# Service Bulletin

## Using **260-0952** Alternator with Pre-2016 Stairmaster Units

*Applies to: 4000-Steppers + SC916 + SC5+ FreeClimber (155015) 7000PT + SM916 + SM5+ Gauntlet (150015)*

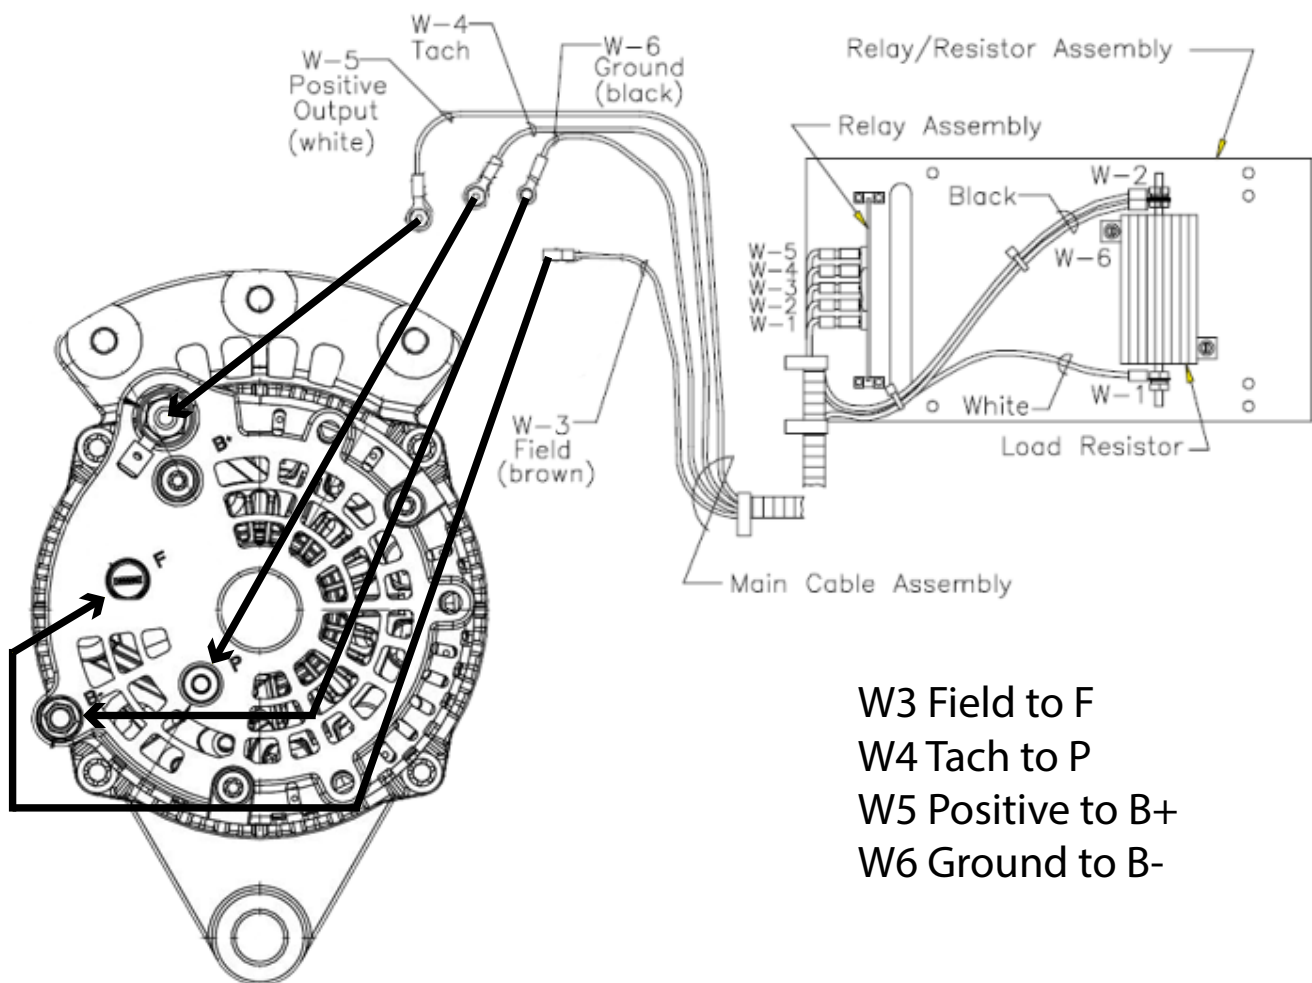
In 2018, a new alternator was introduced (**260-0952**) to replace the original Stairmaster alternator (**SM22900**). While this alternator is backwards compatible to pre-2016 units, the wires connect to it slightly different. Please see below:

W3 Field to F  
W4 Tach to P  
W5 Positive to B+  
W6 Ground to B-
